ISSUE: Certificate of Appropriateness for new construction

APPLICANT: City of Alexandria and Washington Metropolitan Area Transit Authority (WMATA)

BAR#2019-00241
2901 Potomac Ave. (2405, 2501, and 3701 Potomac Ave., 3251 Potomac Ave.
[Parcel ID 016.04-01-01], 700 Carpenter Rd, 1702 & 1880 Potomac Greens Dr.)

**Contract No. FQ16146 - Washington Metropolitan Area Transit Authority
(WMATA) Potomac Yards Metrorail Station
LTR-0104-PM-City of Alexandria January 22nd, 2020 BAR Submission**

Item 19 – East Retaining Wall (NPS)

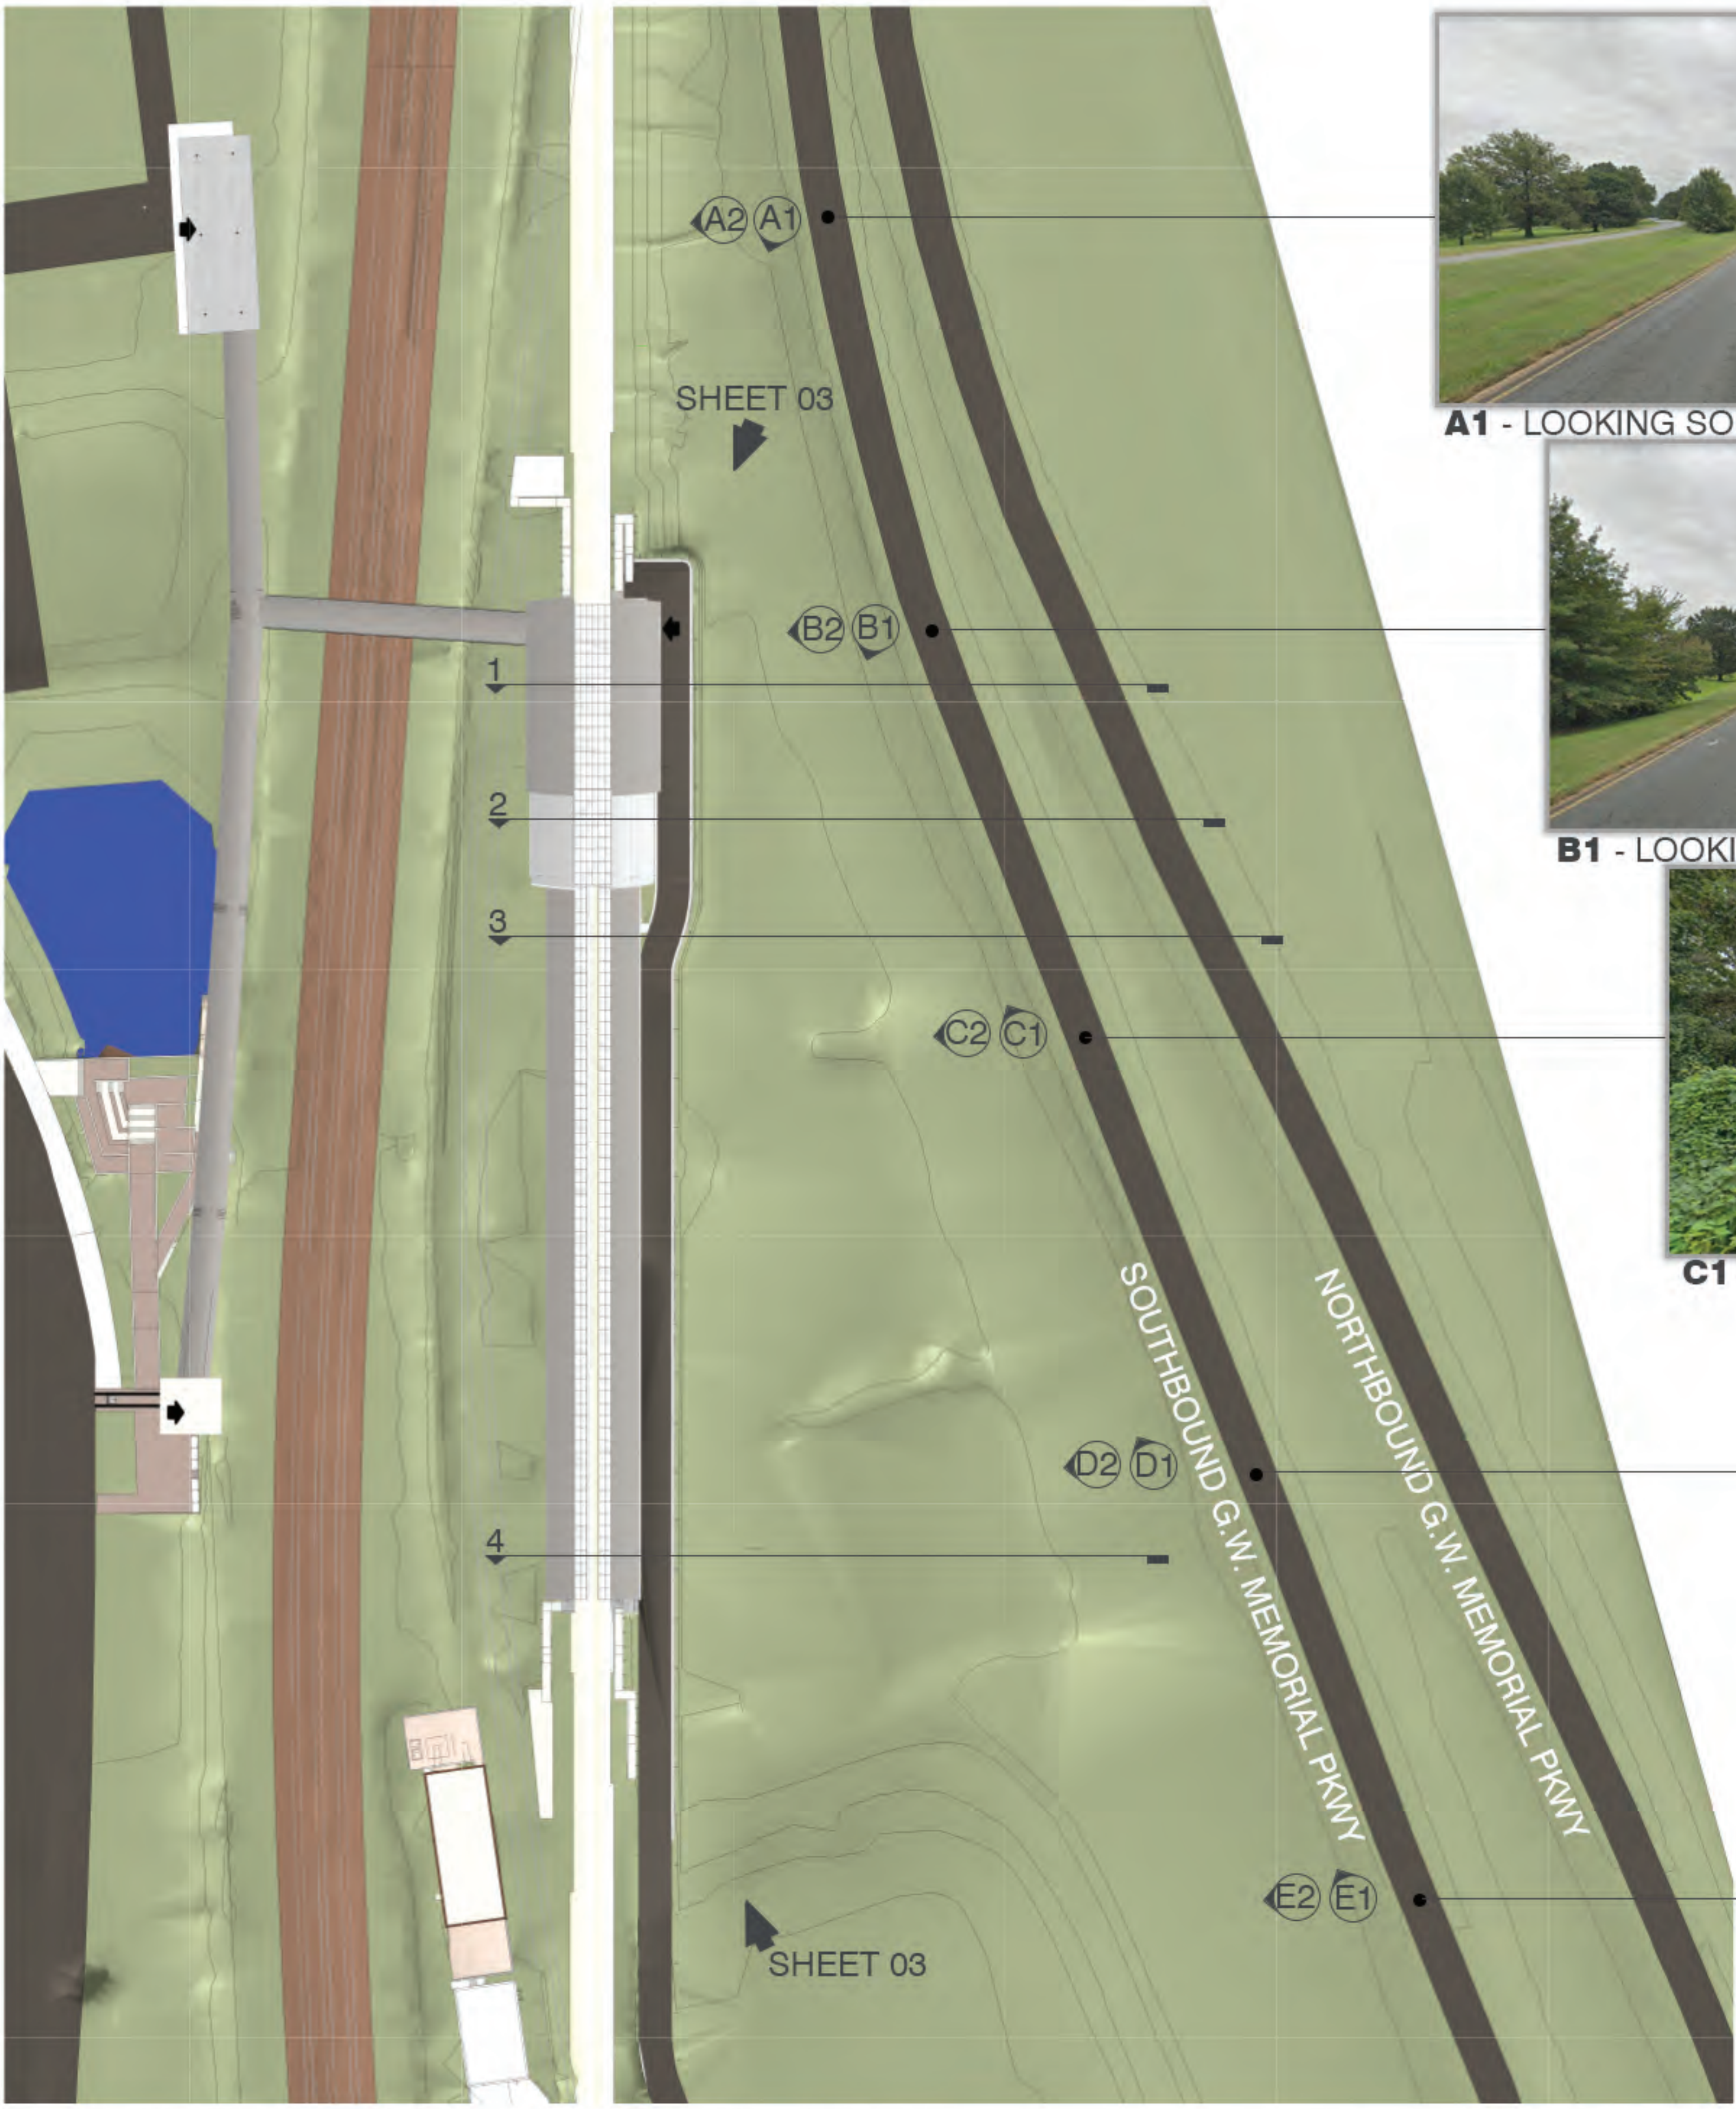
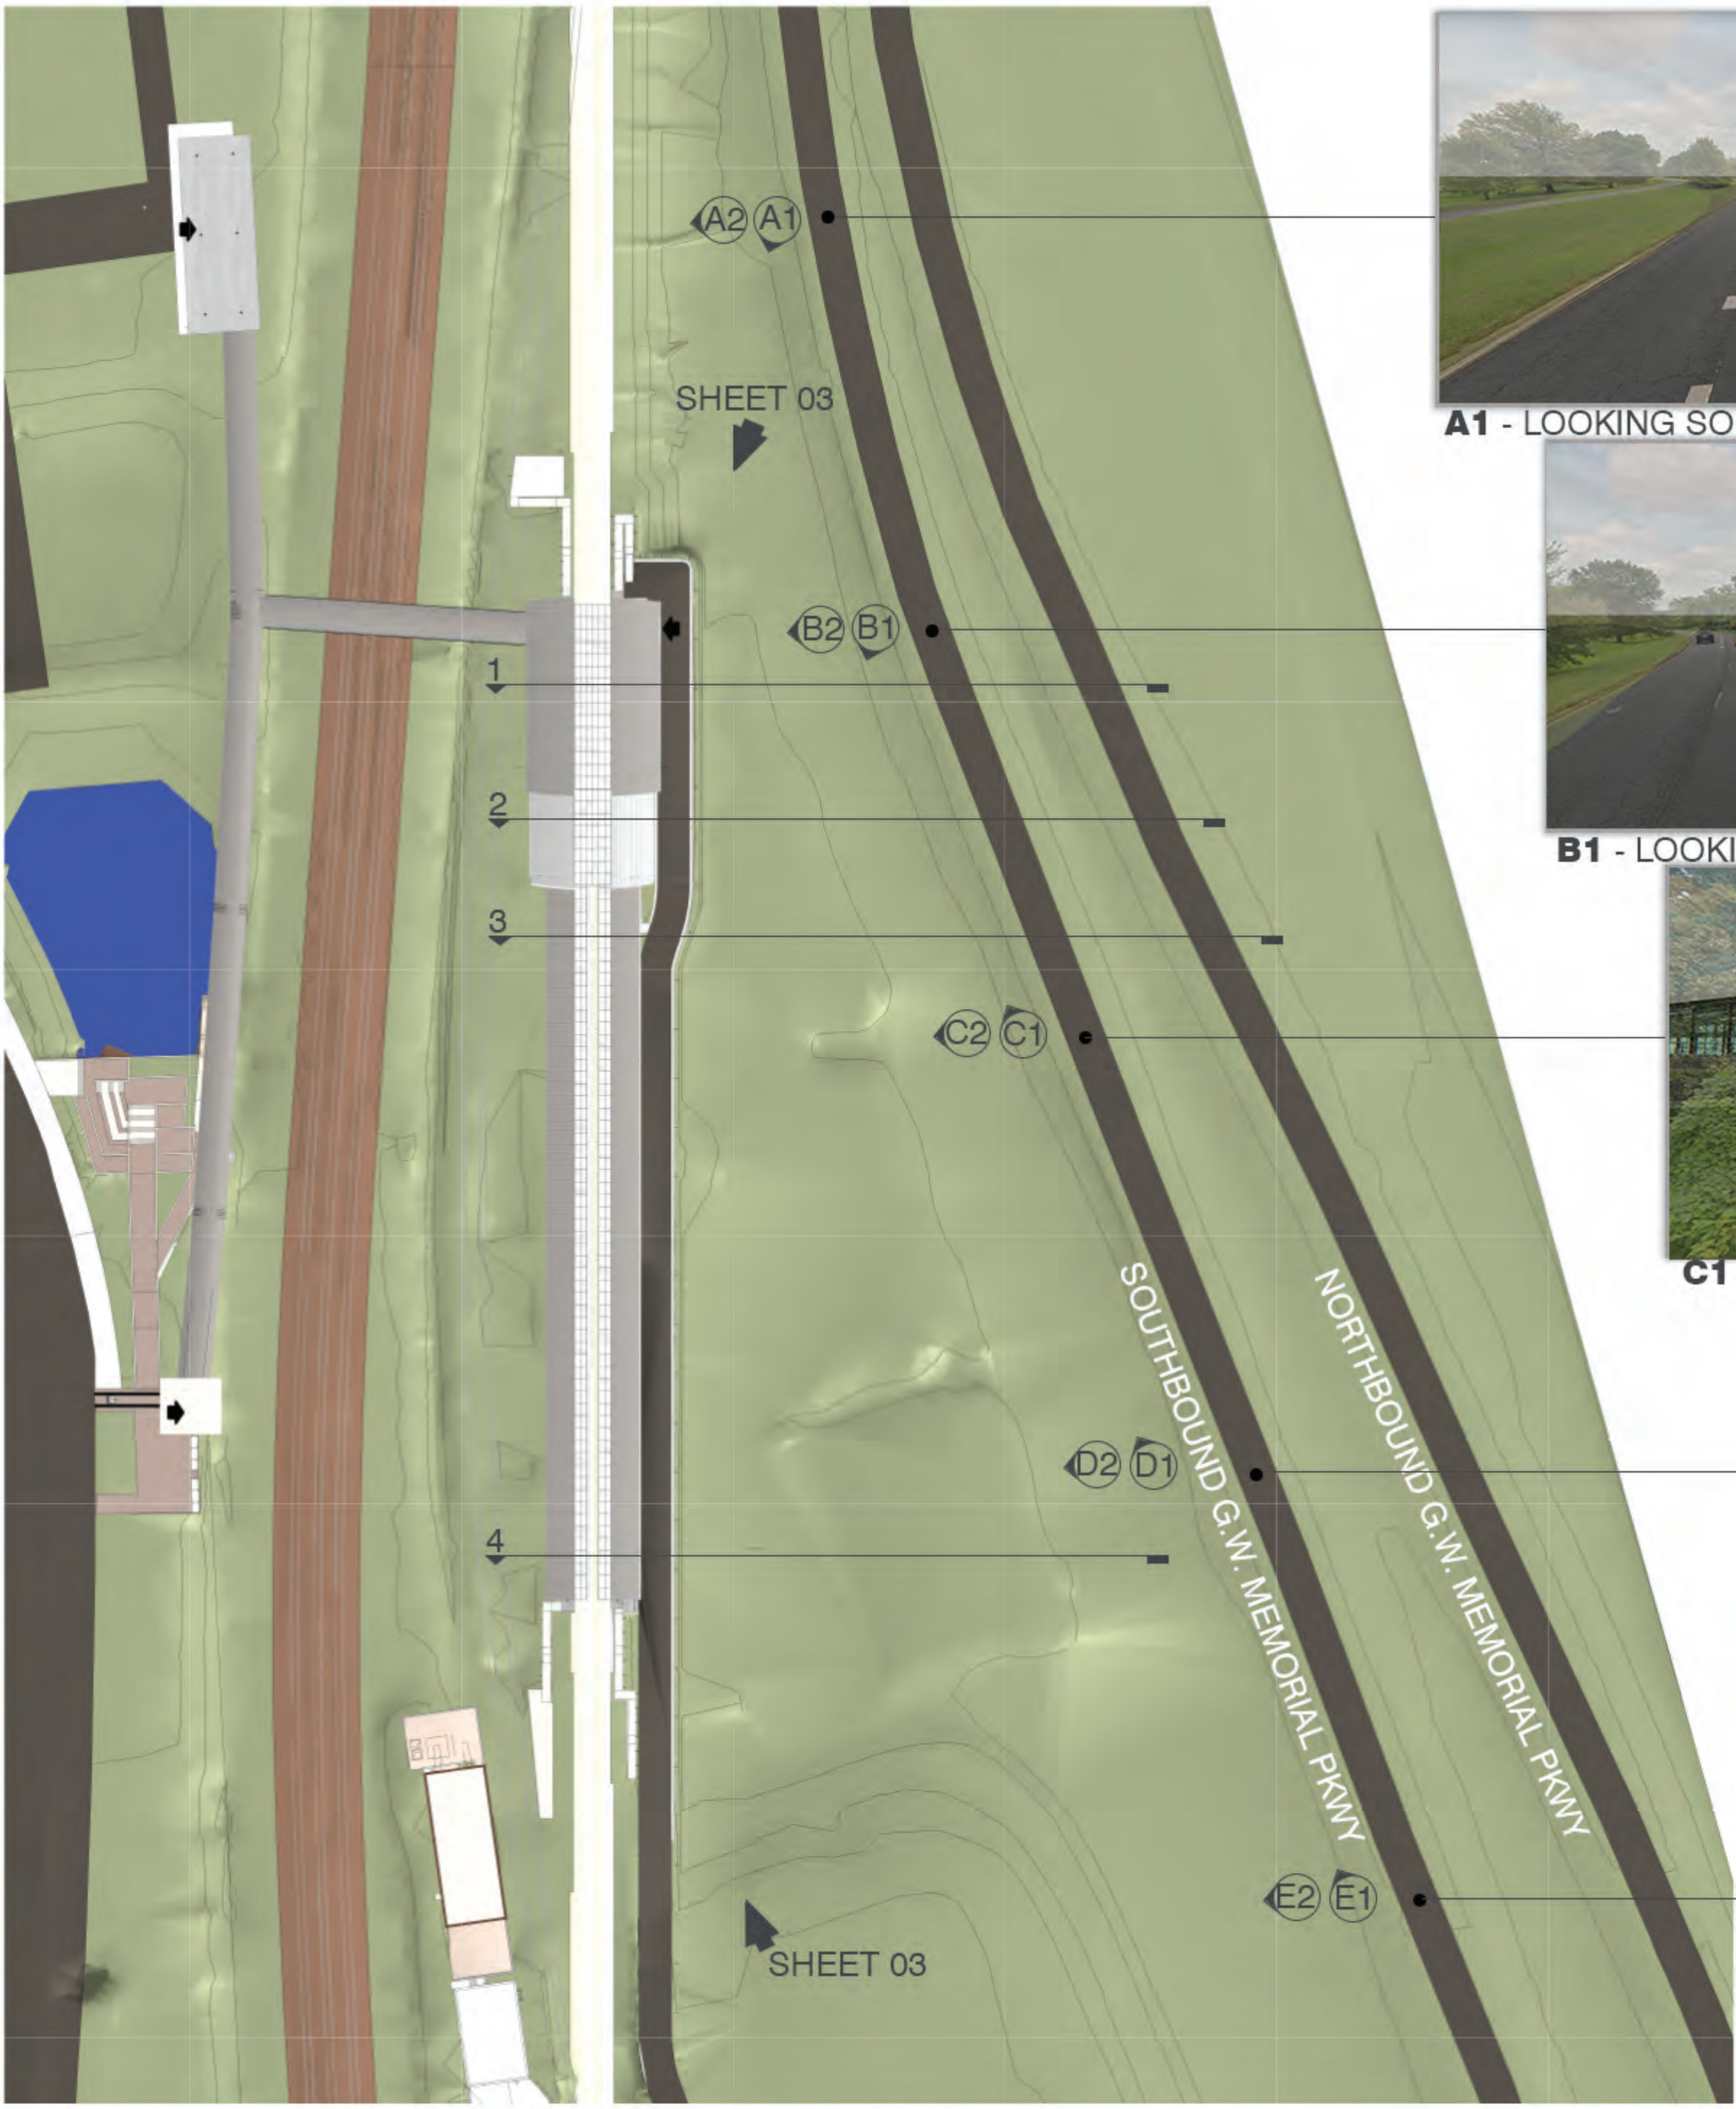
As noted above, the retaining wall design has changed as a result of extensive conversations with the National Park Service. Their landscape architects did not believe that the steep earth slope previously proposed would support native plants and would be an unsightly backdrop to the wetlands. Therefore, a vertical concrete retaining wall clad with fieldstone to match the plinth of the Metro station and historic GW Parkway infrastructure is being proposed. The height of the wall varies depending on the adjacent topography and there is an approximately four-foot wide earth berm at the top of the wall that will support plant material and contain the bases for the pole lights for the service road. Staff believes that the stone retaining wall is a far better solution than the earth berm and, although much of it will be hidden by the plant material in the wetland, it will be more attractive from the Parkway. It is also a safer edge condition for bicyclists and pedestrians on the station service road.

1. Approval of the downspout details with the color of the downspouts to match the adjacent structural feature and final review of the cover plate details by staff; the Chocolate Brown Met color flat exoskeleton finish; and the guardrail and stone retaining wall, as submitted.
2. Deferral of the cast stone details and west elevation of the entrance pavilion on the west side of the tracks, the glass handrail/guardrail details in the station and exoskeleton connection details.
